# Access Compliance Report

## Public Rights-of-Way

### (Curb Ramps)

Intersection ID: 2862	Main Street: BEAUVISTA_DR	Cross Street: HIGHLAND_CREEK_PY	Location: SE
ADA ID: 017578009940	Ramp Type: PerpDiag	Initial Pass/Fail: Fail	Overall Compliance: No
		Severity Score: 25

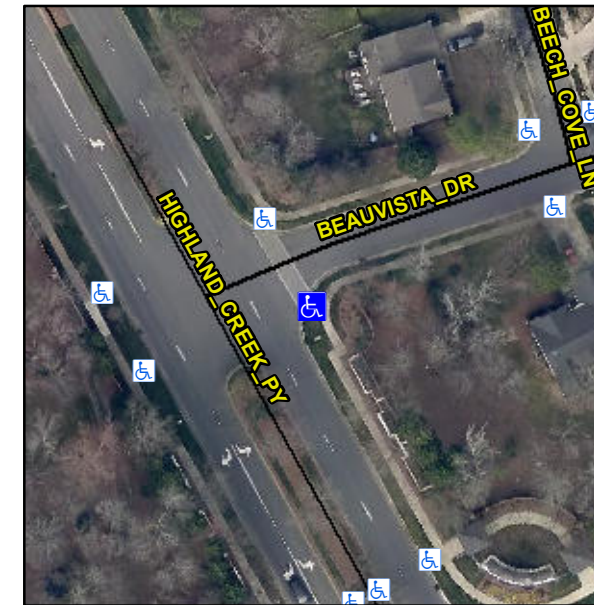
**Not Found, R304.2.2, R304.5.3**

Compliance	Description	Data	Compliance	Description	Data
N/A	Ramp Length (in)	76.0	No	Ramp Slope (%)	8.4
Yes	Ramp Width (in)	48.0	No	Ramp XSlope (%)	5.7
N/A	Flare Type LT	N/A	N/A	Flare Type RT	N/A
N/A	Flare Slope LT (%)	N/A	N/A	Flare Slope RT (%)	N/A
N/A	Flare Traversable LT?	N/A	N/A	Flare Traversable RT?	N/A
N/A	Landing Length (in)	N/A	N/A	DWS Provided?	N/A
N/A	Landing Width (in)	N/A	N/A	DWS Contrast?	N/A
N/A	Landing Slope (%)	N/A	N/A	DWS Length (in)	N/A
N/A	Landing X Slope (%)	N/A	N/A	DWS Full Width?	N/A
N/A	Landing Curb? (Y/N)	N/A	N/A	DWS Offset (in)	N/A
N/A	Shared Landing?	N/A			
N/A	Gutter Ponding?	N/A	N/A	Gutter Slope (%)	N/A
N/A	Gutter Lip Ht (in)	N/A	N/A	Gutter X Slope (%)	N/A
N/A	Painted X Walk1?	Yes	N/A	Painted X Walk2?	No
	X Walk 1 Direction	To N		X Walk 2 Direction	To W
N/A	X Walk 1 Width (in)	120.0	N/A	X Walk 2 Width (in)	N/A
	X Walk 1 Slope (%)	3.2		X Walk 2 Slope (%)	3.0
	X Walk 1 X Slope (%)	2.0		X Walk 2 X Slope (%)	2.7

N/A	Ramp inside XWalk1?	Yes	N/A	Ramp inside XWalk2?	N/A
	Road Slope (%)	4.9	N/A	Clear Space?	N/A
	Road X Slope (%)	2.1	N/A	Clear Space to XWalk (in)	N/A
N/A	Any Obstructions?	N/A	N/A	Storm Grate/Utility Hazard?	N/A
	Obstruction Type			Storm Grate/Utility Type	
		N/A			N/A
			Yes	Surface Condition? (G/P)	Good

**Remove & Replace Curb Ramp With Two New Directional Ramps or Equivalent.**
